**VERIFICATION SURVEY  
OF THE  
BAKER AND WILLIAMS WAREHOUSES  
BUILDING 521-527  
NEW YORK, NEW YORK**

The report titled, Verification Survey of the Baker and Williams Warehouses Building 521-527 New York, New York, has been reviewed. The enclosed comments are enclosed for your use in preparing the final report.

**Comments on the Draft Report - Verification Survey of  
the Baker and Williams Warehouses, Building 521-527,  
New York, New York**

FIGURE 2: Floor Plan of Building 521-527 Ground Level

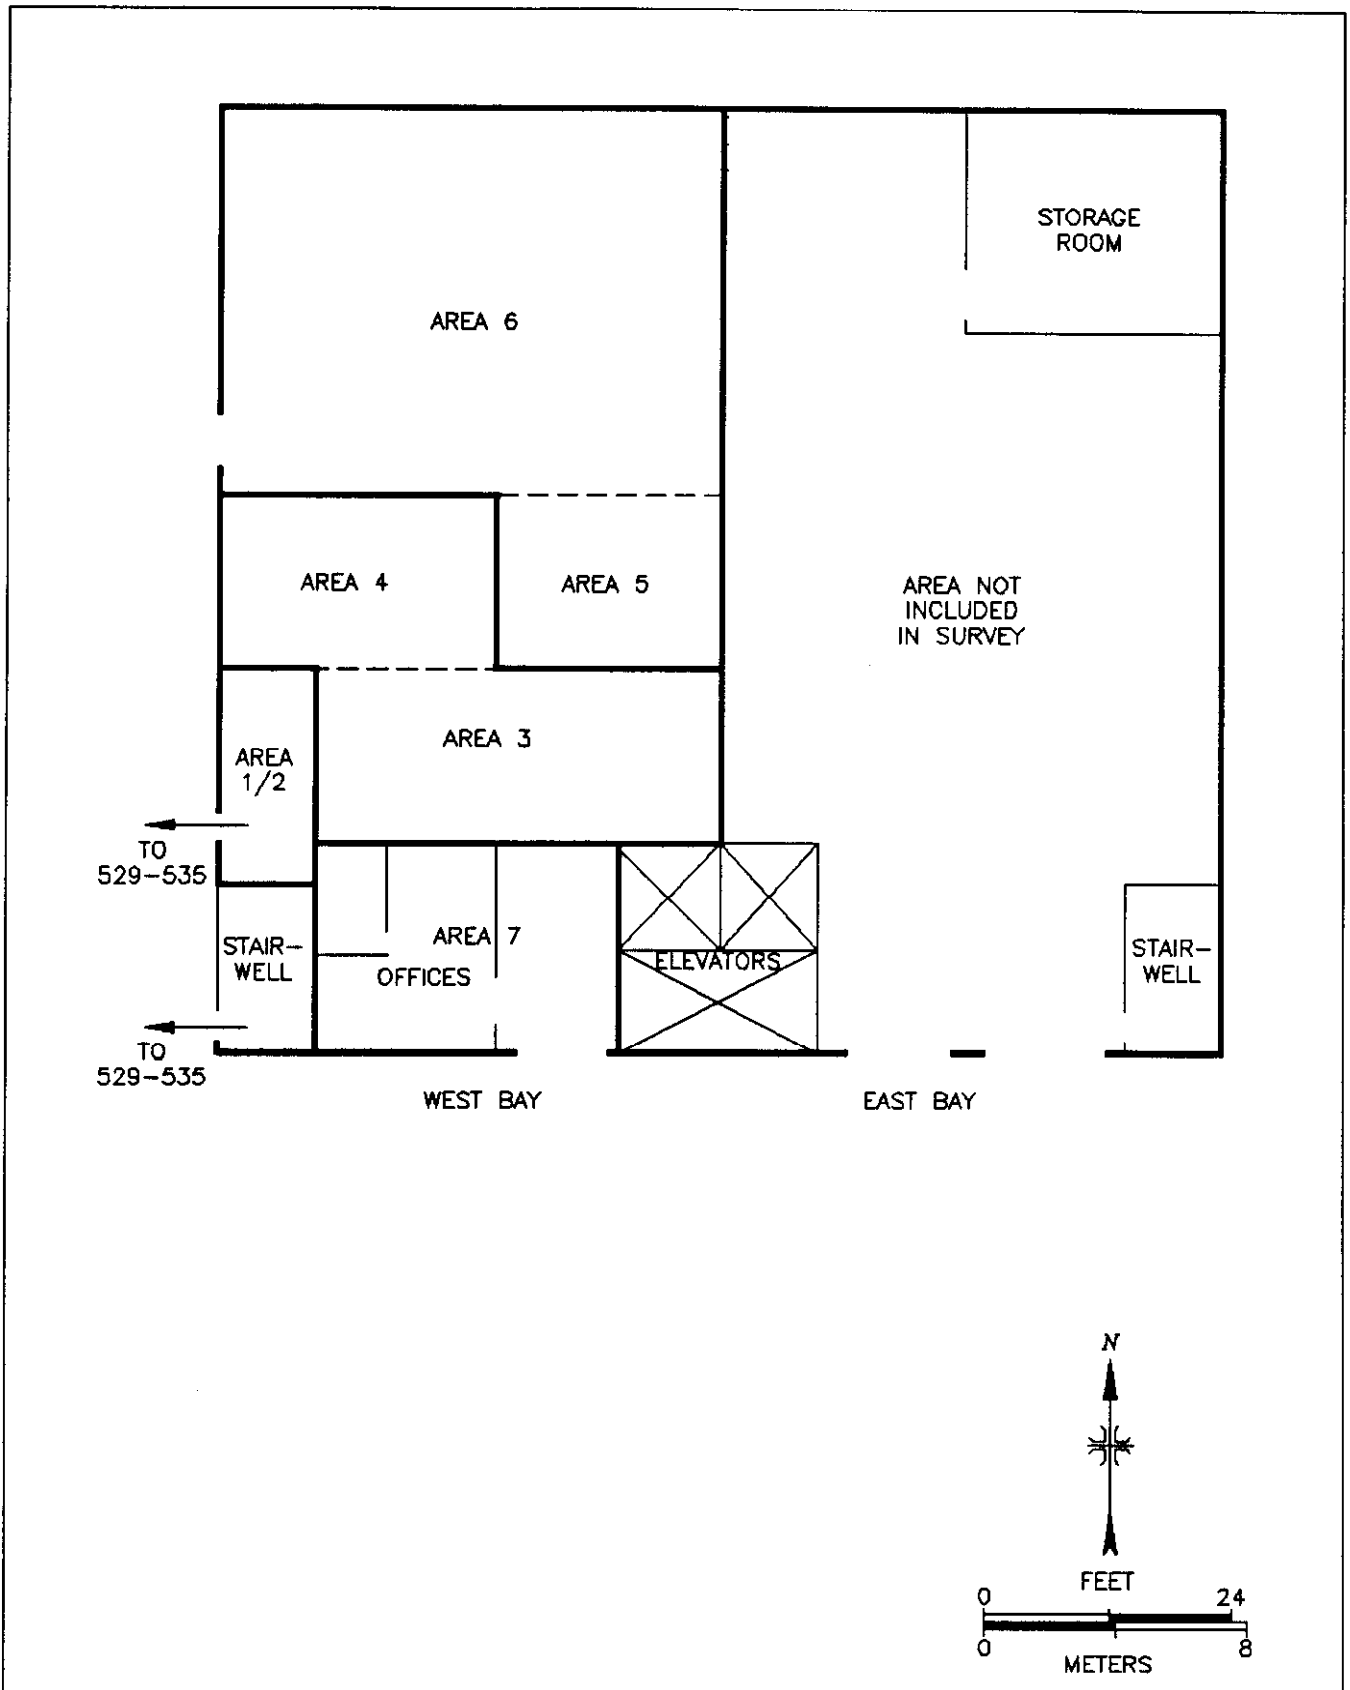
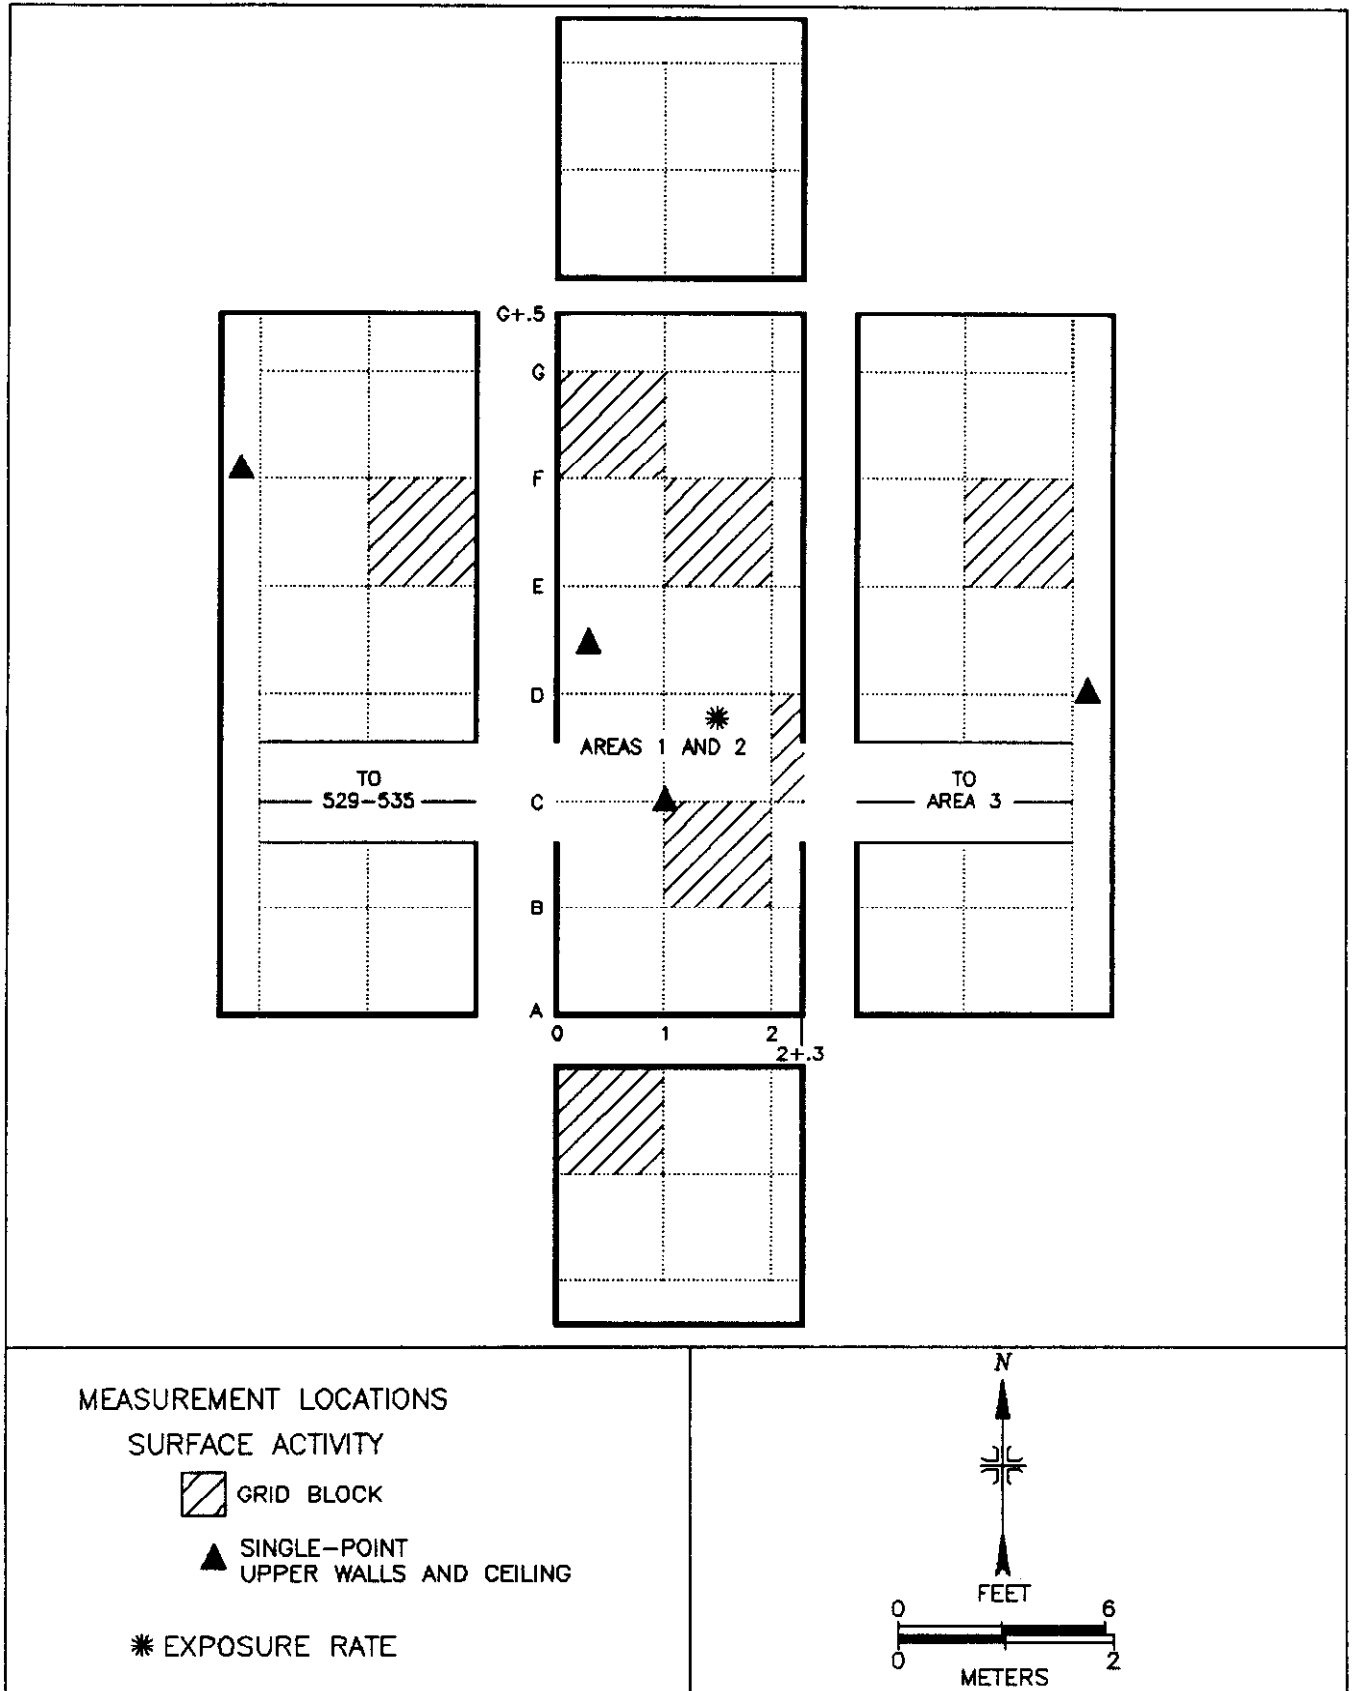
Page 12, Figure 2 and page 14, Figure 4 - The difference in the figures, both of the ground level, should be addressed in the text.
